ARKANSAS NUCLEAR ONE - UNIT NO. 1

Amendment No. 16  
License No. DPR-51

ATTACHMENT TO LICENSE AMENDMENT NO. 16

SAFETY EVALUATION BY THE OFFICE OF NUCLEAR REACTOR REGULATION

TABLE 6.2-1

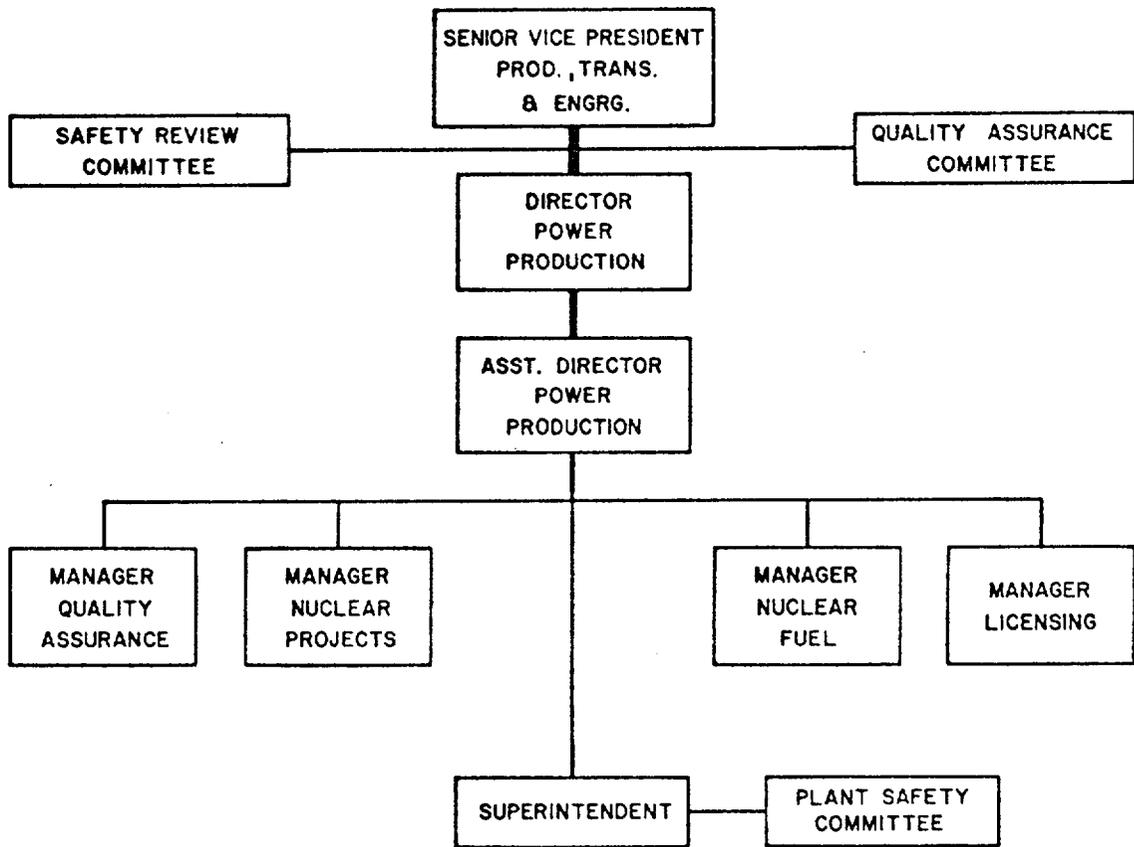
2. Update of the minimum shift crew composition (Table 6.2-1) to meet present NRC requirements.
3. Revision of Figures 6.2-1 (Management Organization Chart) and 6.2-2 A and B (Functional Organization for Plant Operation) to reflect current management and staff organizations.
4. Delineation of the audit responsibilities of the Safety Review Committee (Specification 6.5.2.8).
5. Changes to the Respiratory Protection Program to update the specifications (6.11) to present NRC requirements.
6. Revision of all Section 6 specifications to be consistent with the format and content of the NRC Standard Technical Specifications.
